NEW MILLENNIUM PROJECT CONFIGURATION CHANGE REQUEST

PROGRAM <u>EO-1</u>		TITLE <u>CHANGES TO EO-1 ALI ICD-18 (A)</u>	
CCR NO. <u>0028</u>		ORIGINATOR <u>R. Welsh/GSFC</u>	
DATE INITIATED <u>02/03/99</u>		ORIGINATOR'S CHG. NO. _____	
		SPONSOR/CODE <u>R. WELSH/EO-1ALI</u> PHONE <u>x9774</u>	
EFFECTIVITY		CHANGE CLASS

PRELIMINARY INTERFACE REVISION NOTICE (PIRN) No. 003

5. CI'S AFFECTED:
ALI ICD-18 (A)

Figure 3-3. Deployed Spacecraft With Coordinate System (Sun is Normal to the Page)

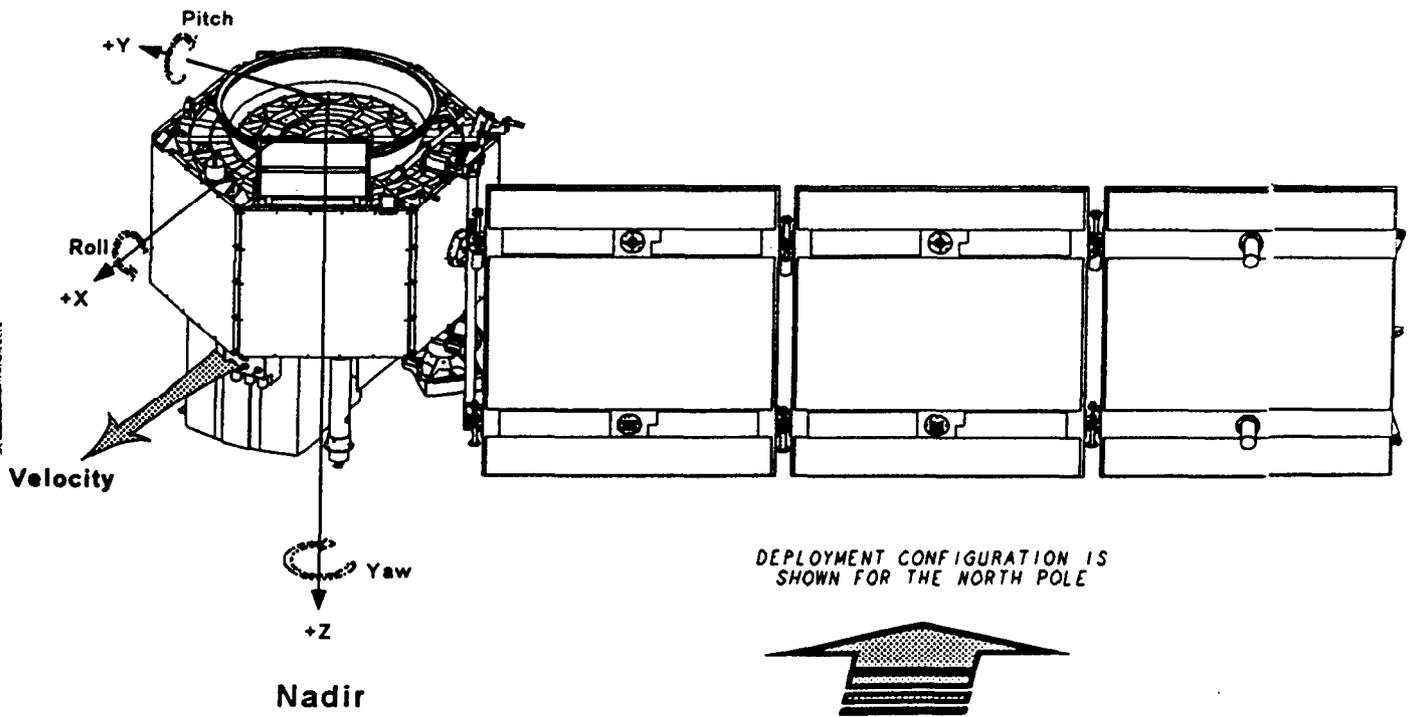
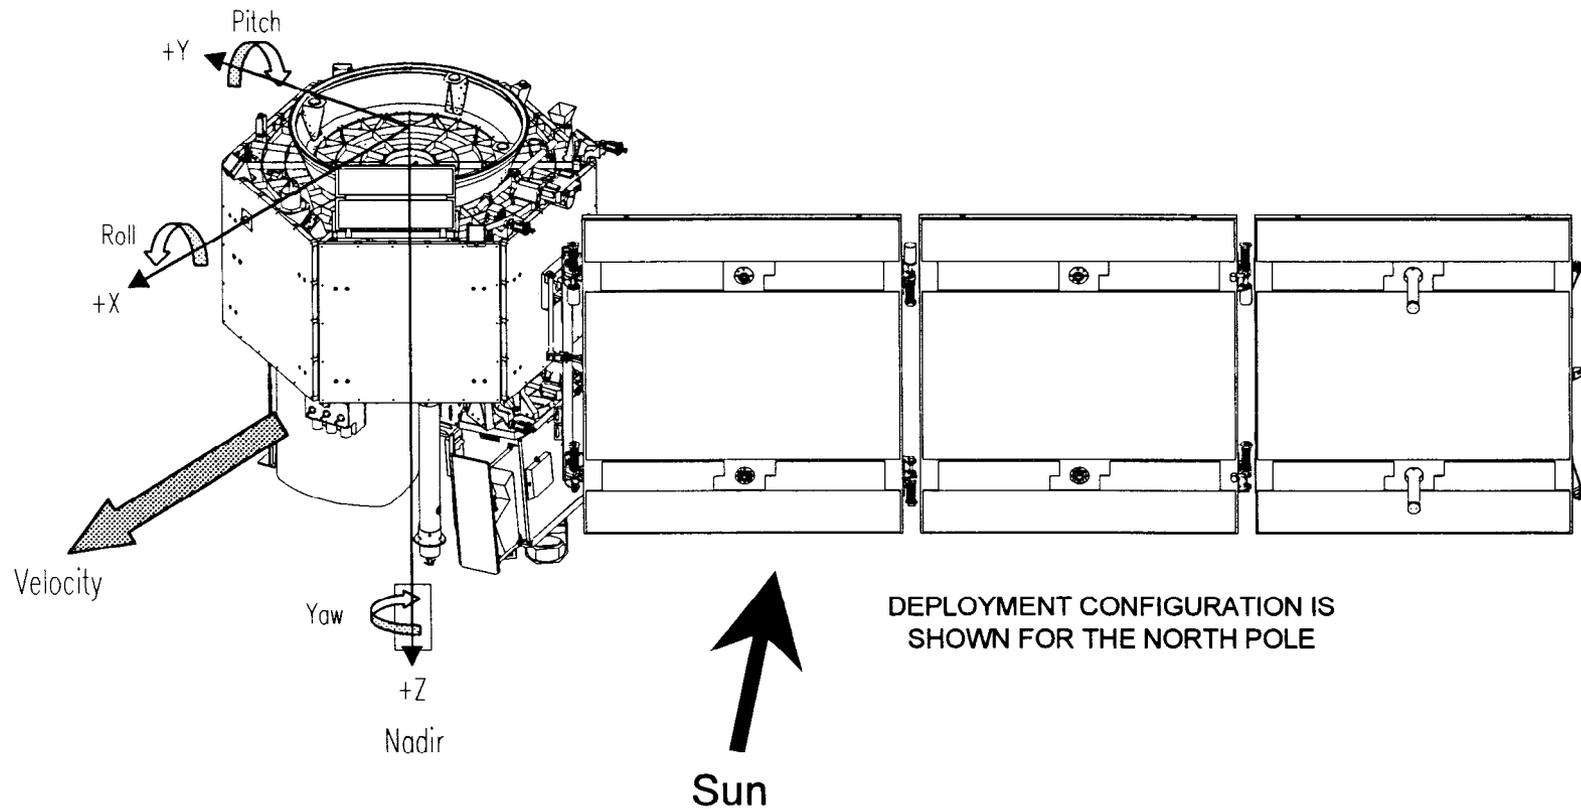
*42. Change Figure 3-3 Deployed Spacecraft with coordinate system

FIG 3-3 Deployed Spacecraft with Coordinate System

Figure 3-5. Instrument Electrical Block Diagram

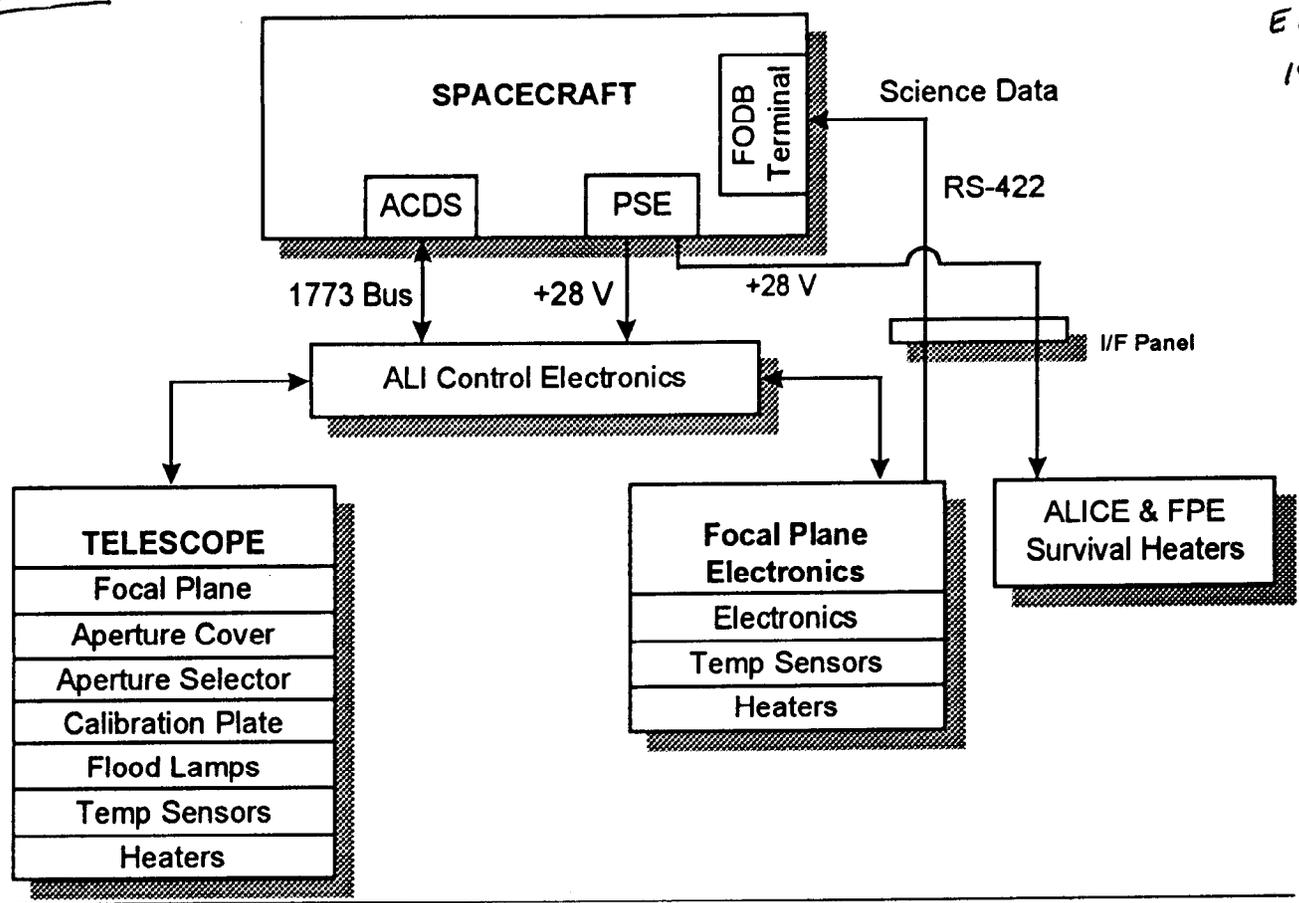
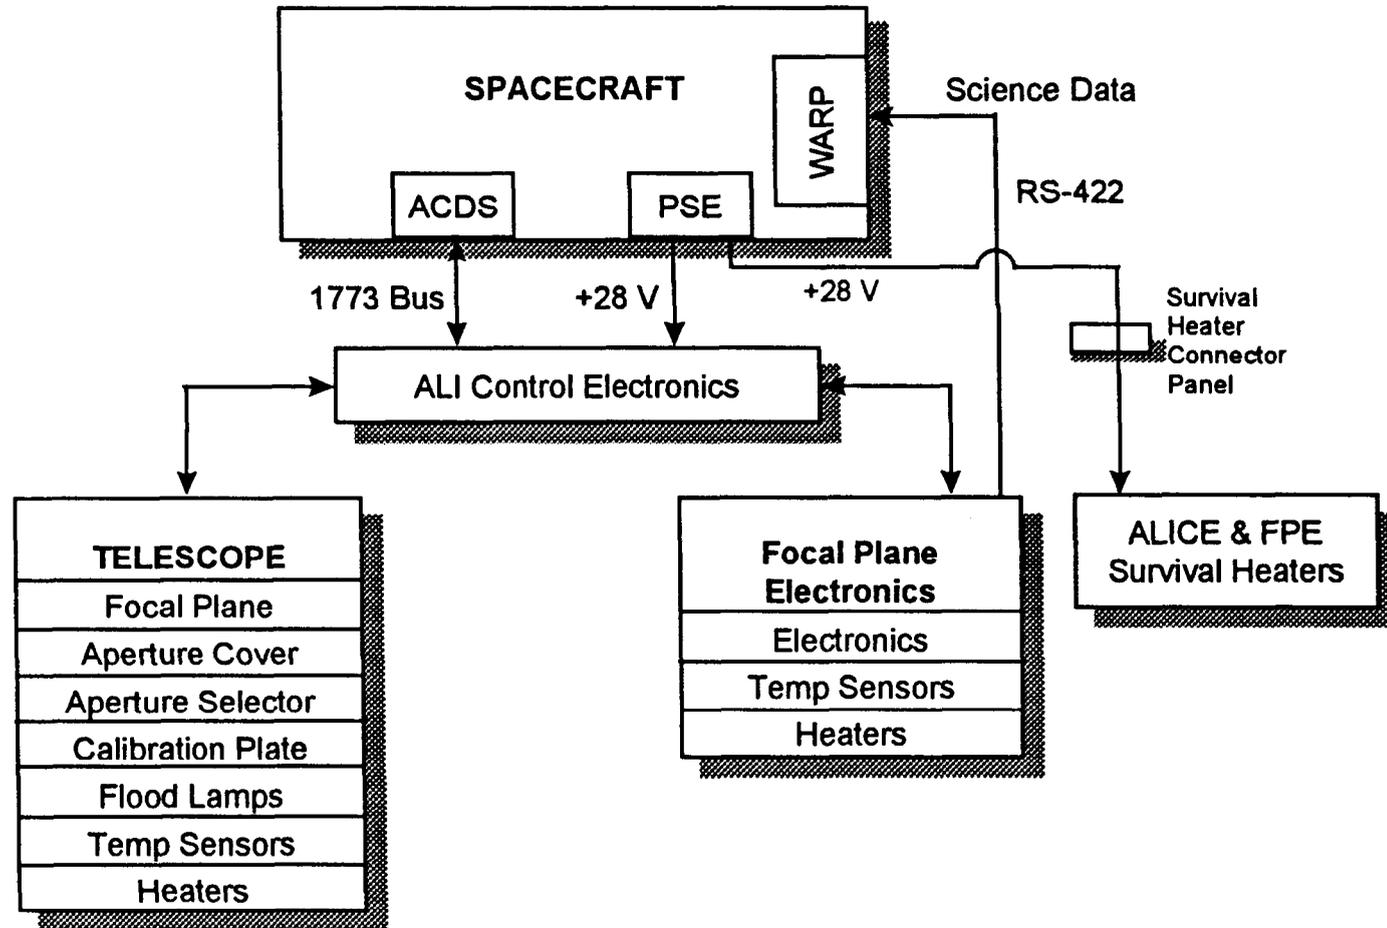
From: An RS-422 Science data interface connector panel will be located on the instrument pallet near the -X, -Y corner of the pallet, as shown in ALI Interface Control Drawing A0750. Power and 1773 connections are at the ALICE electronics box. The power connection for the electronic box survival heaters is also at the interface panel. Figure 3-5 is an electrical block diagram of the ALI.

To: ~~An RS-422 Science data interface connector panel will be located on the instrument pallet near the -X, -Y corner of the pallet, as shown in ALI Interface Control Drawing A0750.~~ **ALI RS-422 Science data will be transmitted via a dedicated harness which connects the ALI FPE directly to the WARP. This harness will be fabricated at MIT/LL and then provided to Swales for completion. (dressing and termination at the WARP end.)** Power and 1773 connections are at the ALICE electronics box. The power connection for the electronic box survival heaters is also **at the survival heater connector panel.** ~~at the interface panel.~~ Figure 3-5 is an electrical block diagram of the ALI.

Figure 3-1. EO-1 Configuration (Outer Panels Not Shown)

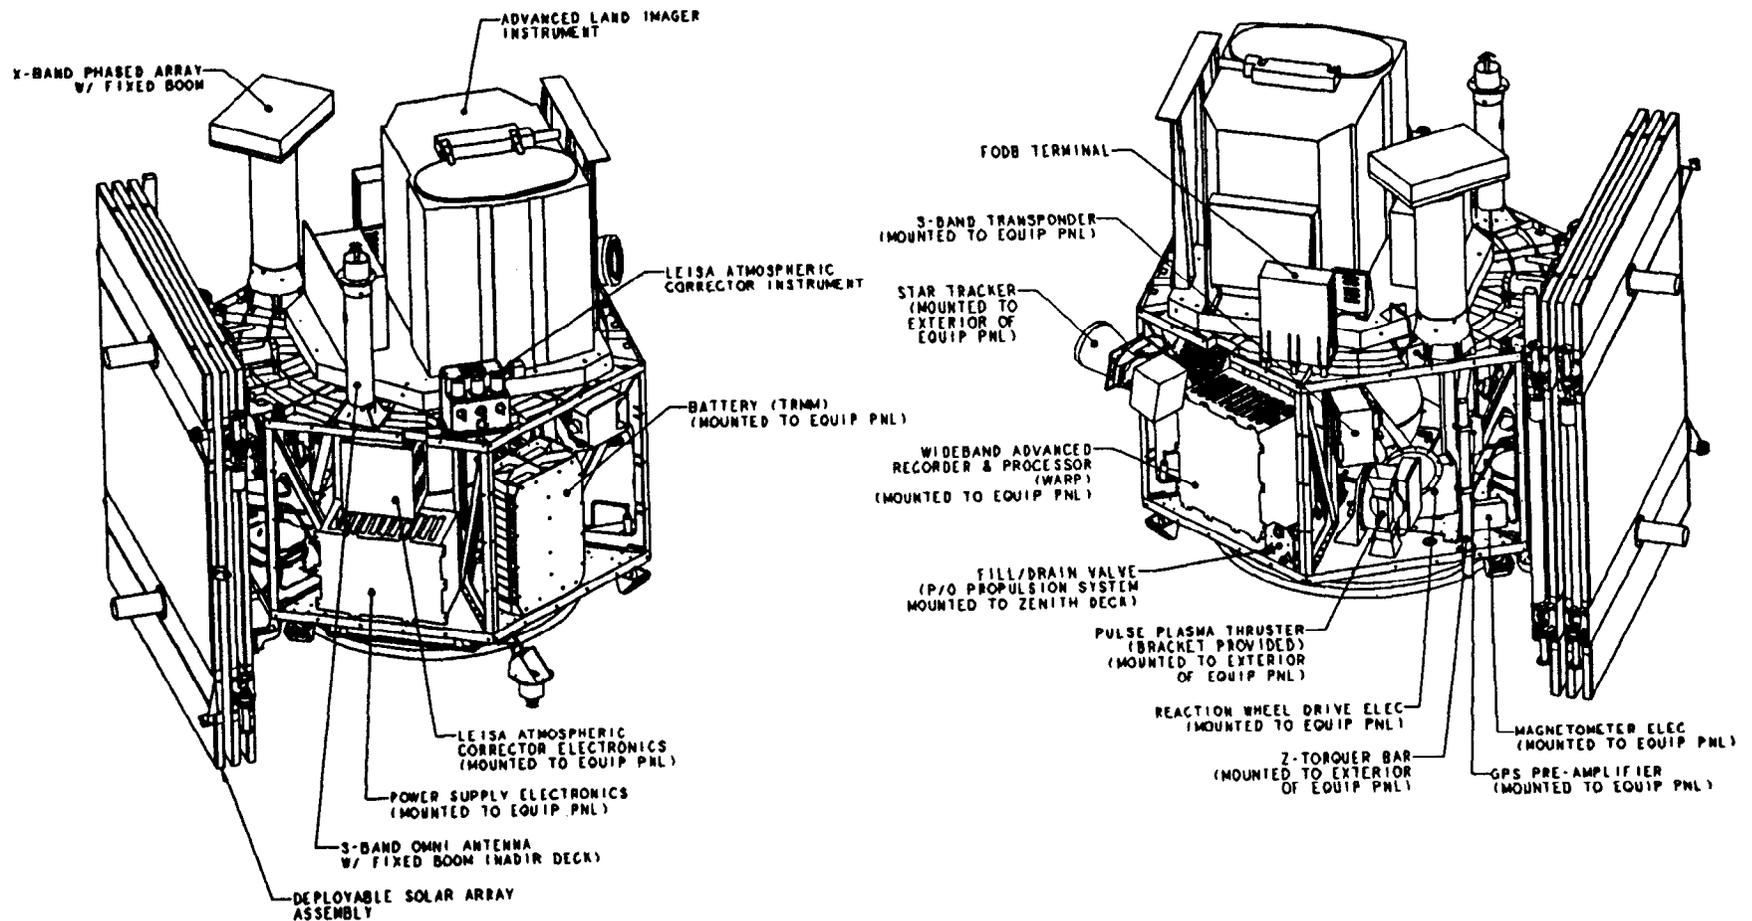
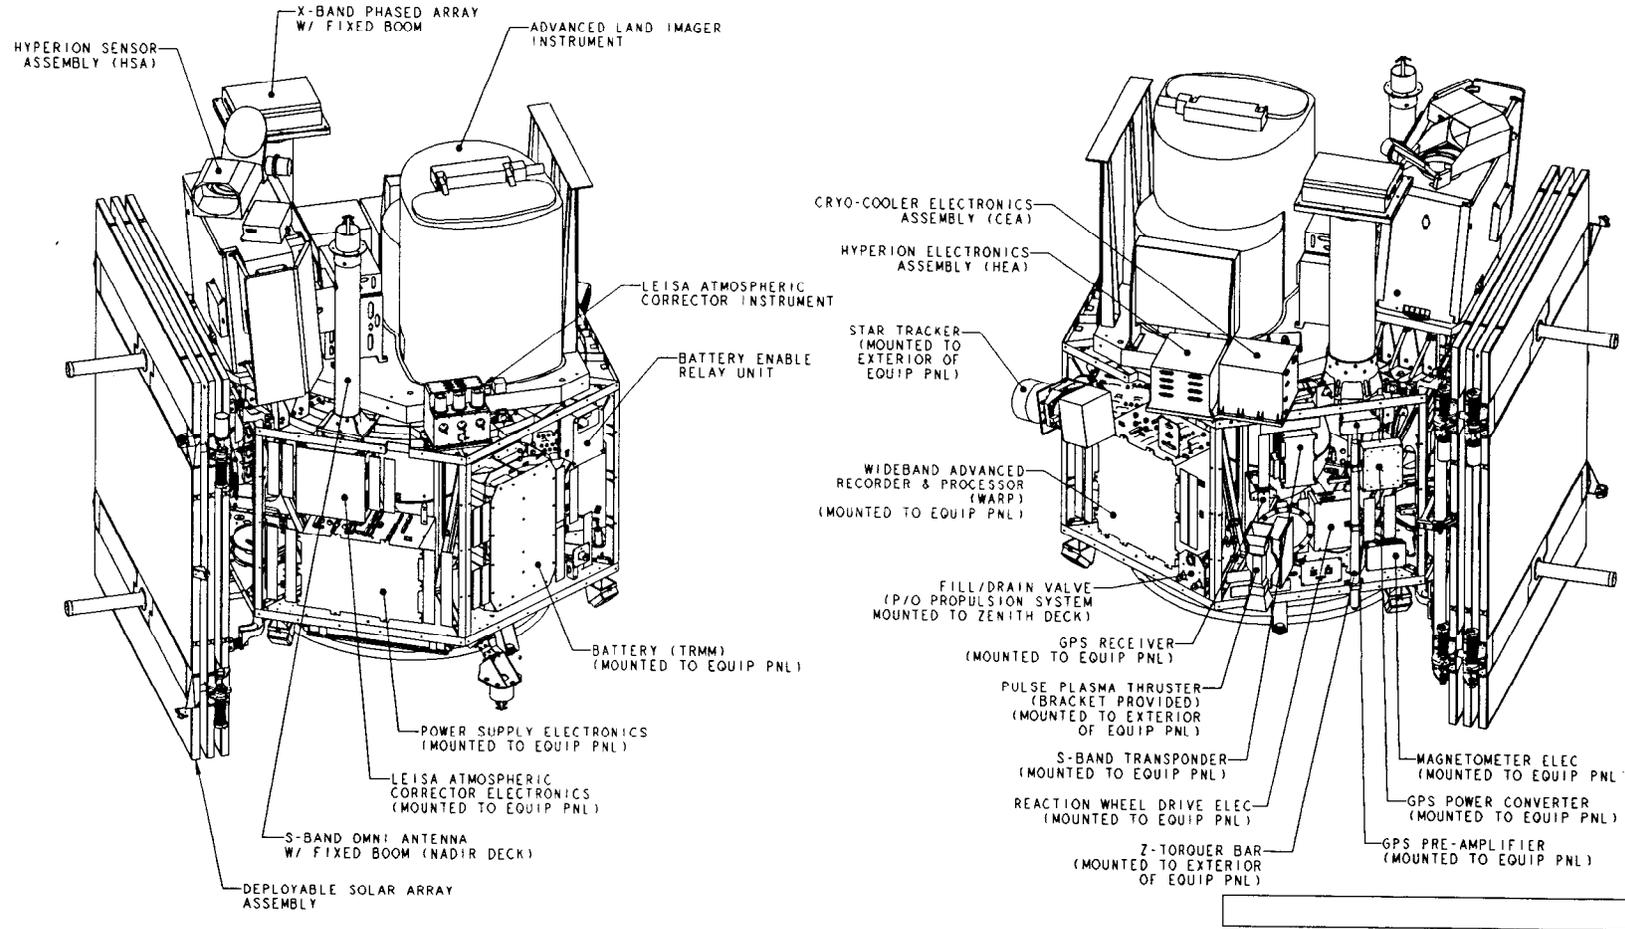
*41. Change Figure 3-1 EO-1 Configuration

FIG 3.1 EO-1 Configuration
